# RUSSIAN MARITIME REGISTER OF SHIPPING

**No. 313-13-1326c**

amendments to the Rules for the Classification and Construction of Sea-Going Ships, 2020, ND No. 2-020101-124-E

### **PART VI. FIRE PROTECTION**

Fig. 6.4.1

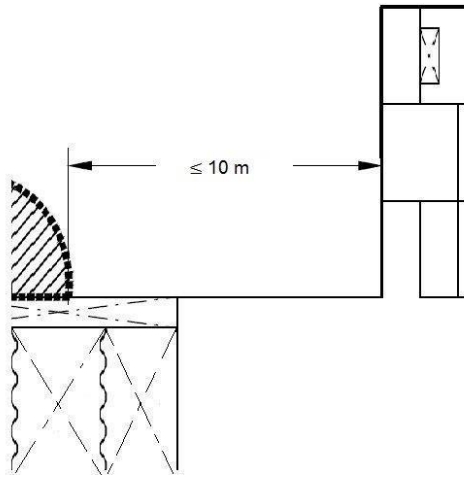
2 **Para 6.4.1** is replaced by the following text:

The requirements of 2.4.3 for fire insulation of "A-60" class exterior boundaries, as well as the requirements of 2.4.4 and 2.4.5 for openings in these boundaries are applicable to the ships with cargo tanks aft of the superstructure, provided the exterior boundaries of superstructures and deckhouses enclosing accommodation, including any overhanging decks which support such accommodation, are situated 10 m and less of the nearest hazardous area (refer to Fig. 6.4.1 of the present Part and 19.2.3 of Part XI "Electrical Equipment").
